In the matter of Applications for resource consents, and a Notice of Requirement for a Designation, by Wellington Water Limited on behalf of Upper Hutt City Council, for the construction, operation and maintenance of the structural flood mitigation works identified as the Pinehaven Stream Improvements Project

Memorandum of counsel for Wellington Water Limited in response to 2nd Minute of Independent Hearing Panel

Dated 16 July 2020

Figure B.3 – SKM Jacobs example cross-sections at 27 Elmslie Road

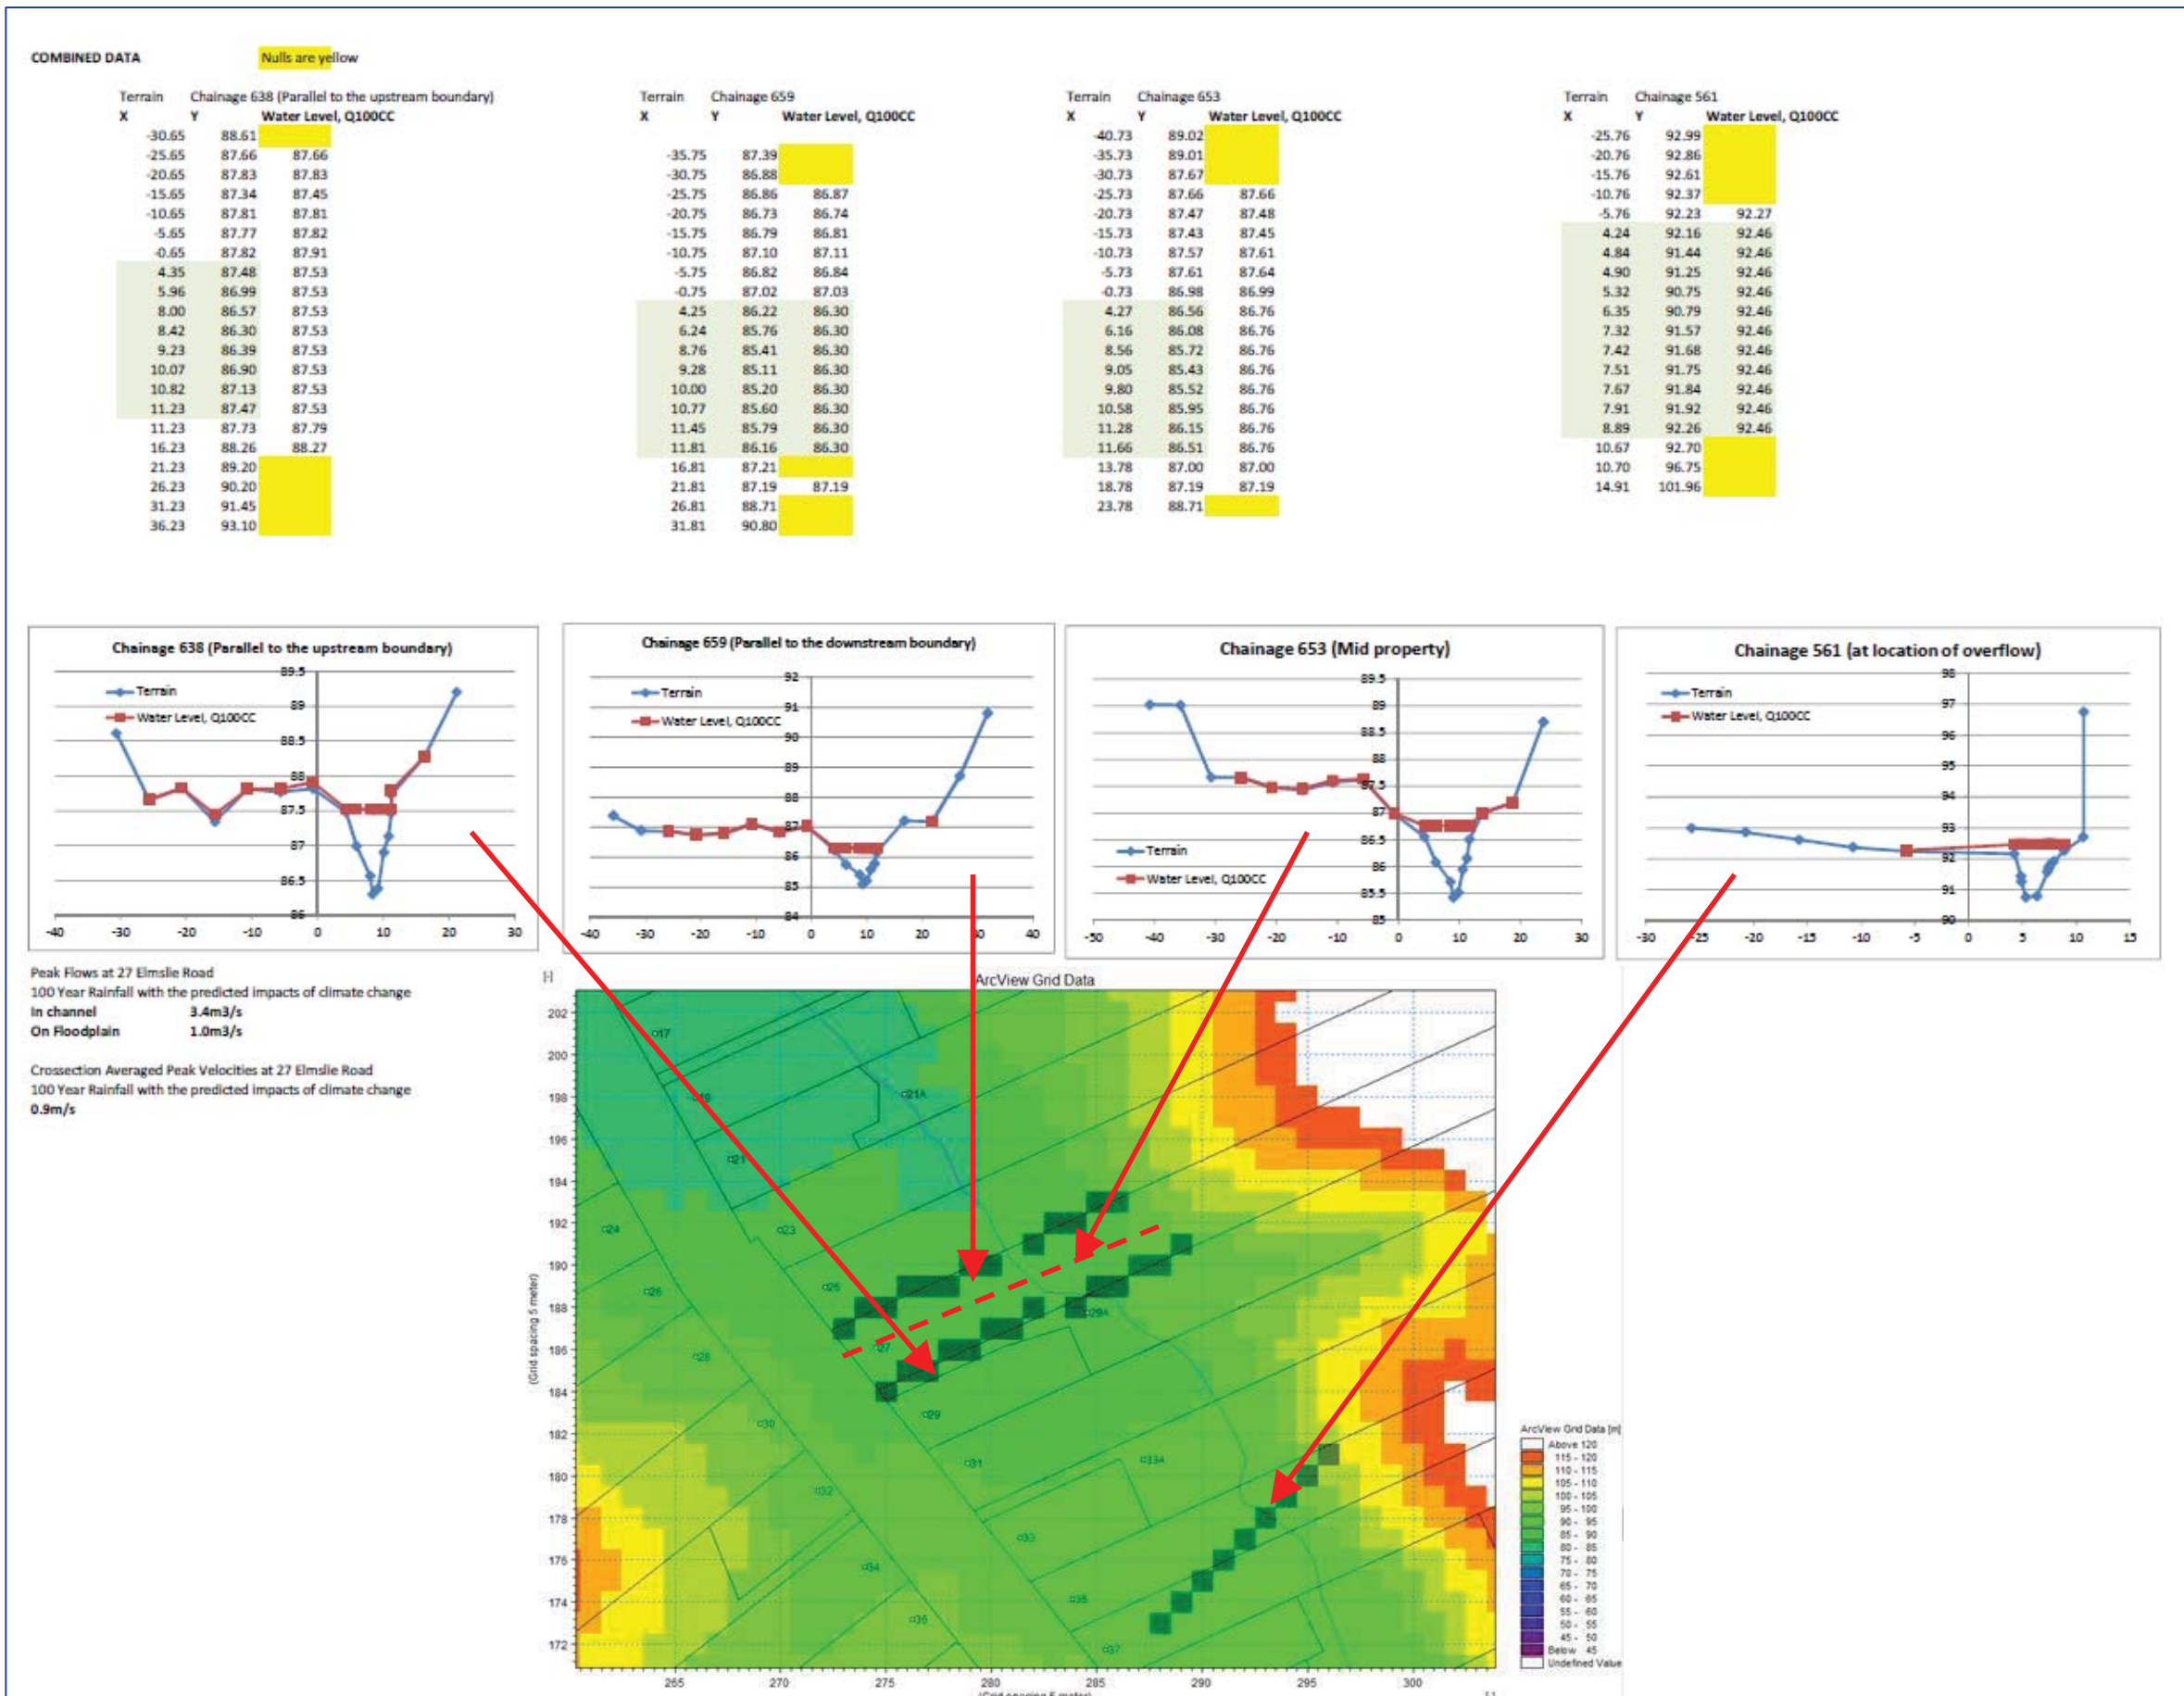
One critical area of difference between SOH's understanding of flood/hazard extents relates to the water surface across the cross-section. As noted above, SOH assumed that the water surface is flat, while SKM have provided cross-sections that indicate that the water level varies across the cross-section. Figure B.3 in Appendix B shows modelled water levels for SKM's sections in the vicinity of 27 Elmslie Road. The water levels were extracted from the 2D surface model results. They indicate shallow flooding (as low as 10 mm) at the margins of the floodplain, and lower water levels in the main channel. This may be due to overland flow paths on the floodplain carrying flow that has broken out from the stream channel upstream.

We note that the varying water level surface is confirmed by the Q100 flood map (Figure 5.1), which shows that flood depth across the site is less than 500 mm. If the water surface were flat across the cross-section, flood depth of more than 500 mm could be expected close to the stream channel due to the slope of the ground. With the water level surface dipping towards the stream, the active cross-section area will be lower than the 15 m² that was calculated by SOH, and hence the calculated flow will also be lower.
